**CERTIFICATE OF APPROPRIATENESS**

**Property:** 540 Columbia Street, Lot 22, Block 286, Houston Heights Subdivision. The property includes a historic 1,840 square foot, one-story wood frame single-family residence and a detached garage situated on a 6,600 square foot (50' x 132') interior lot.

**Proposal:** Alteration – Revision. *The HAHC approved a COA in January 2015 to construct a 1,512 square foot two story addition behind and on top of the residence, remove two original windows on the north side, remove one original window and install two new windows on the south side, replace non-original windows with wood windows, replace vinyl, cementitious, wood and asbestos siding with wood 117, remove a non-original front stoop, re-expose an original inset porch, and move the house 8' closer to the north property line, from current 10'-9" setback to 3'.*

**SITE PLAN**

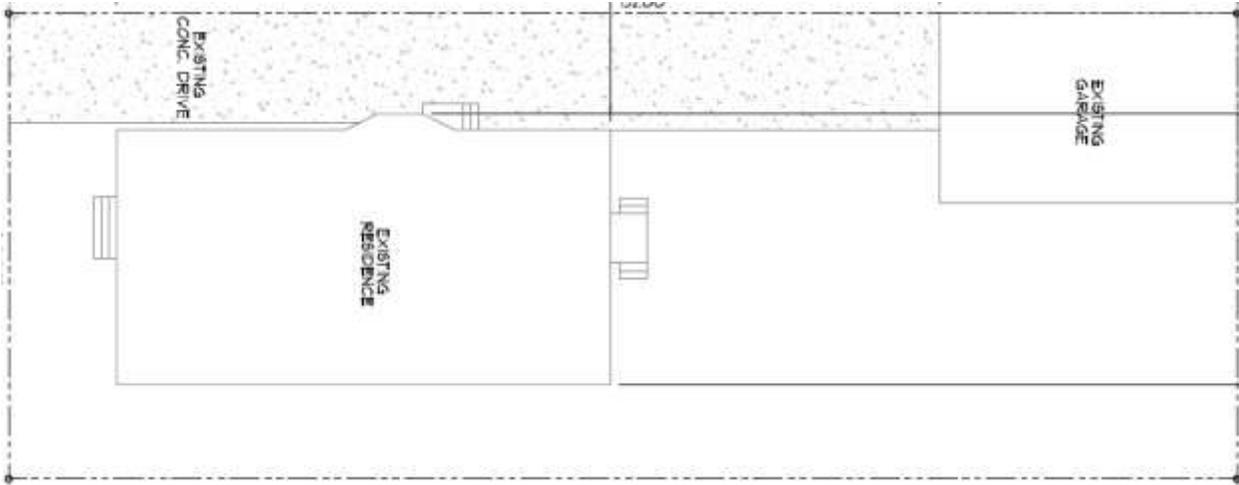
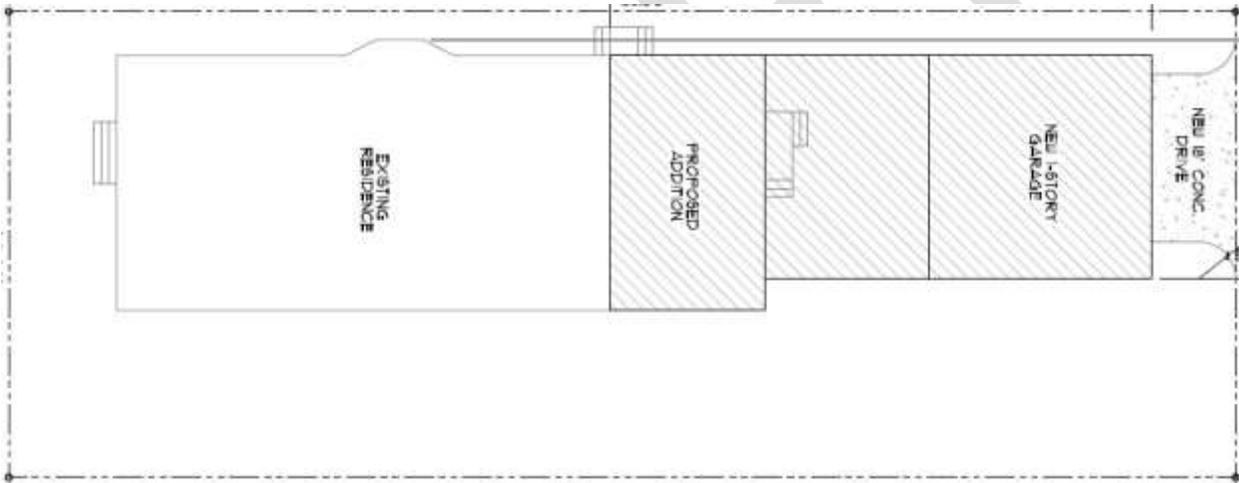
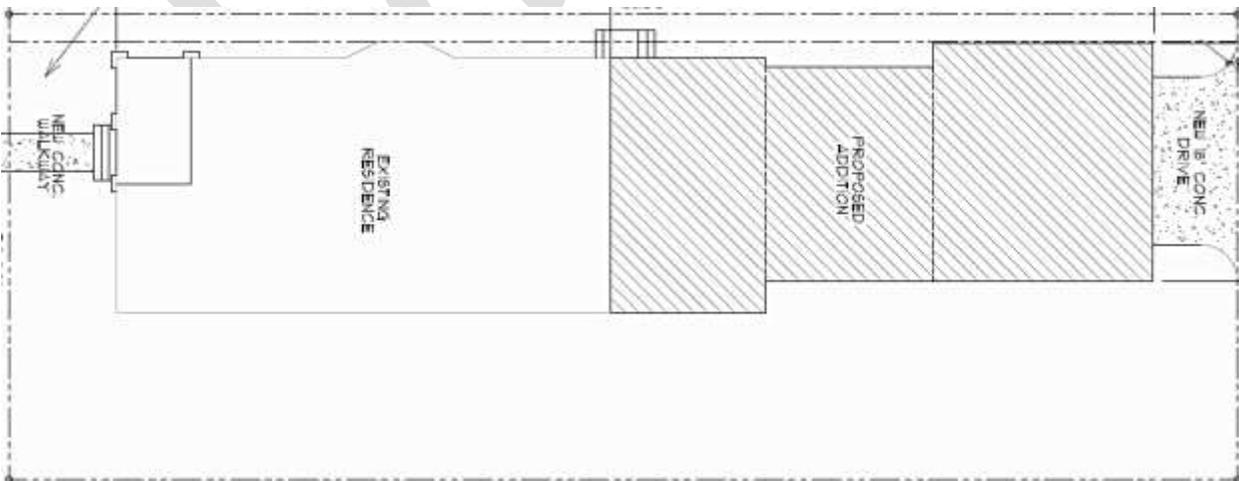
- The attached garage will be 1'-8" wider
- The north setback of the attached garage will be reduced to 3'
- The north eave of the attached garage will be reduced from 2' to 1'
- The front gable window will be decreased in size
- The window pattern on the south wall of the addition will be altered

**ROOF PLAN**  
EXISTING

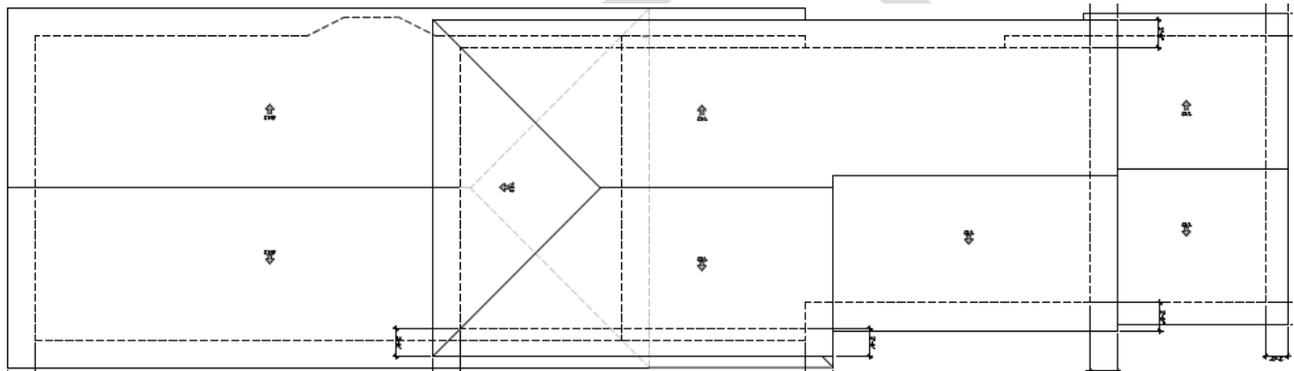
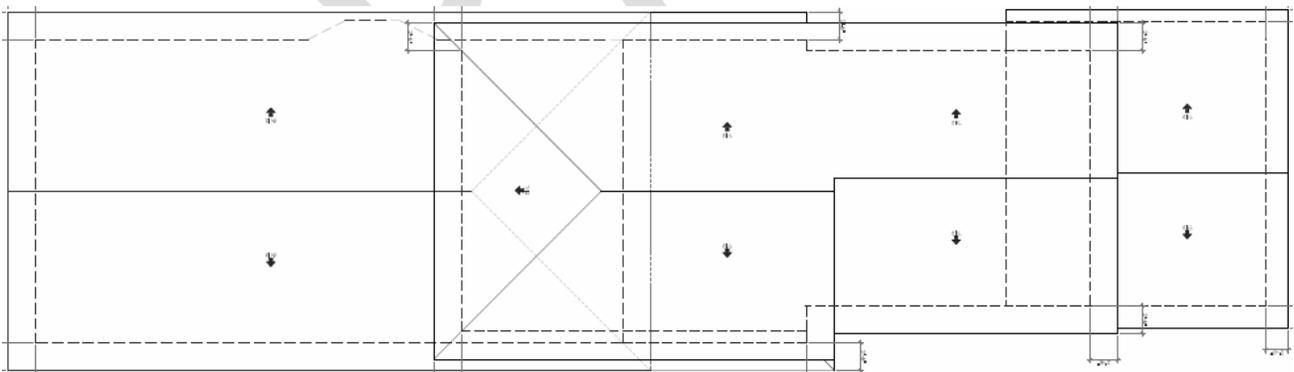
I have NO OBJECTION to the granting of a revised Certificate of Appropriateness for this project. The proposed additional width of the garage and the reduction of the roof overhang in the same location is not a significant change in the visual character of the proposed addition.
